HISTORIC AND DESIGN REVIEW COMMISSION

August 19, 2015

Agenda Item No: 8

HDRC CASE NO: 2015-317
ADDRESS: 205 E CAROLINA ST
LEGAL DESCRIPTION: NCB 3010 BLK 8 LOT 11
ZONING: R6 H
CITY COUNCIL DIST.: 1
DISTRICT: Lavaca Historic District
APPLICANT: Elizabeth & Kevin Ball
OWNER: Elizabeth & Kevin Ball
TYPE OF WORK: Site work

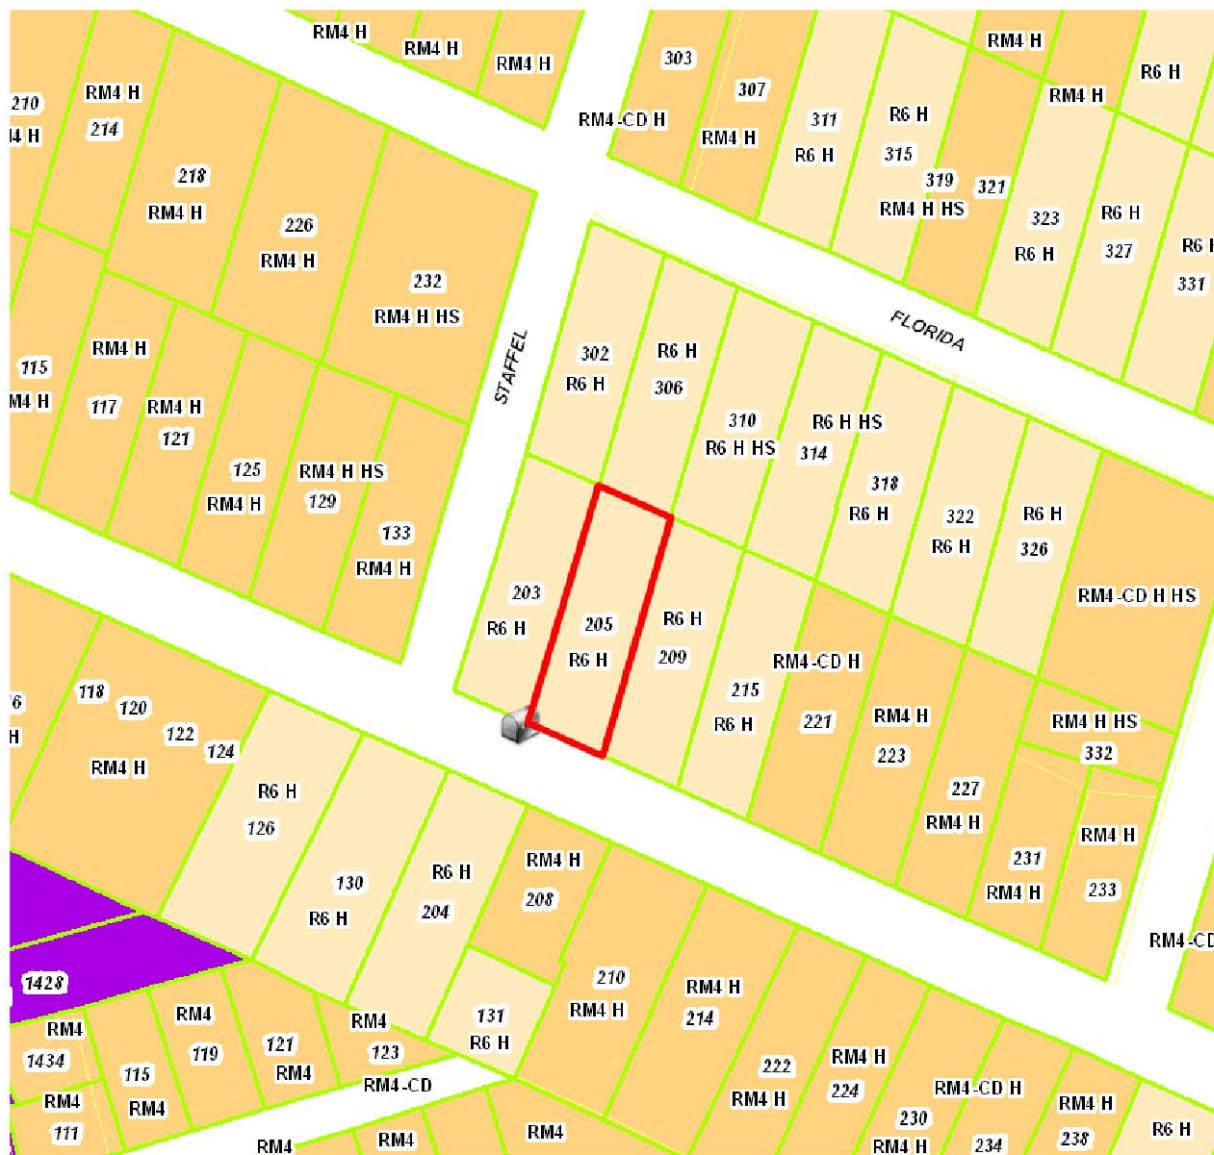
- a. The applicant has proposed to replace the existing, cracking concrete driveway with $\frac{3}{4}$ inch midnight path stone lined with ledgers. According to the Guidelines for Site Elements 5.B.i., historic driveways should be retained and repaired in place to match the existing materials, width and design. The applicant's proposal is not consistent with the Guidelines.
- b. Currently, there is a concrete sidewalk leading from the sidewalk that runs parallel with Carolina to the front porch of the primary historic structure. The applicant has proposed to remove the existing concrete sidewalk and replace it with charcoal Holland 4 x 8 pavers. According to the Guidelines for Site Elements 5.A.ii., sidewalks and driveways should be replaced only when deteriorated beyond repair and every effort should be made to match the existing

sidewalk color and material. The applicant's proposal is not consistent with the Guidelines.

Staff does not recommend approval of items #1 and #2 based on findings a and b. Staff recommends that the applicant replace the existing, cracking concrete driveway to match the existing in color and materials if the existing is damaged beyond repair.
